DRAWING PACKAGE - PART 3002 COUPLING HUB

CURRENT REVISION: B

ACME PRECISION MACHINING	
PART NO	**3002**
PART NAME	**COUPLING HUB**
MATERIAL	**EN8**
SCALE	**1:1**
UNITS	**MM**
GEN. TOLERANCE	**±0.05**
SURFACE FINISH	**Ra 1.6**
DRAWN / REV	**SK / B**

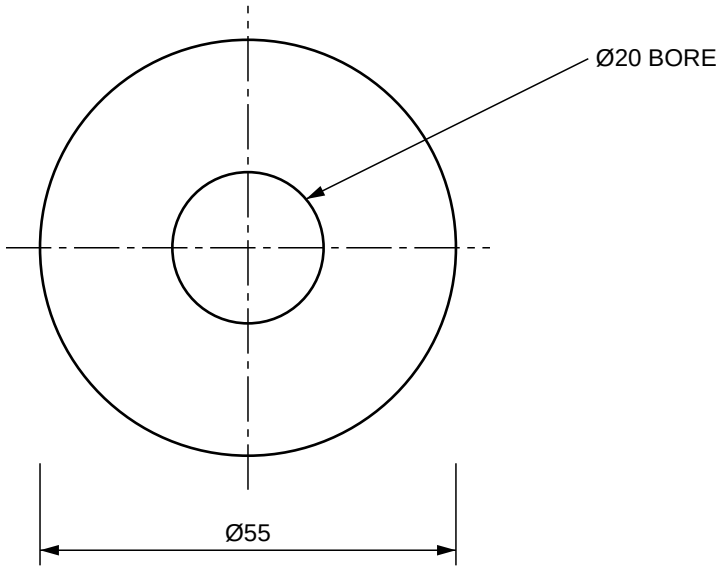
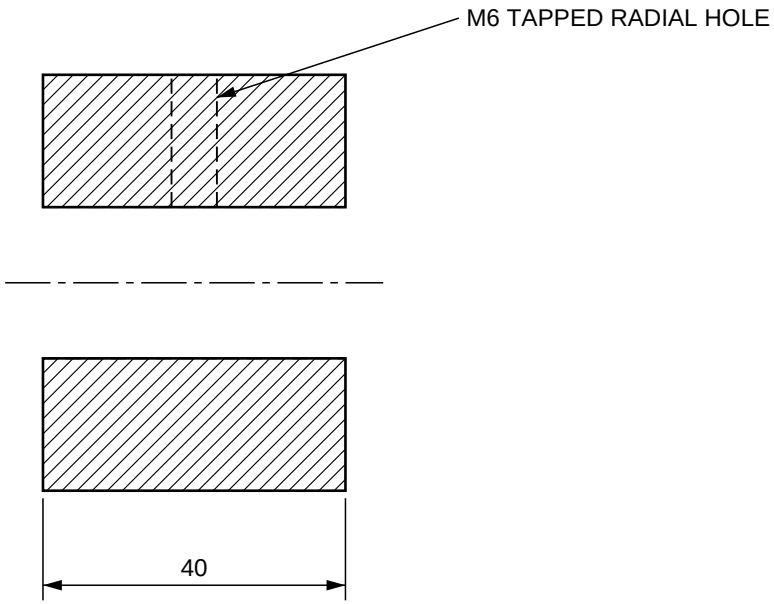
REV	DATE	DESCRIPTION
A	2026-03-02	INITIAL RELEASE. BORE D18, MATERIAL C45.
B	2026-09-14	BORE INCREASED TO D20. MATERIAL CHANGED TO EN8.
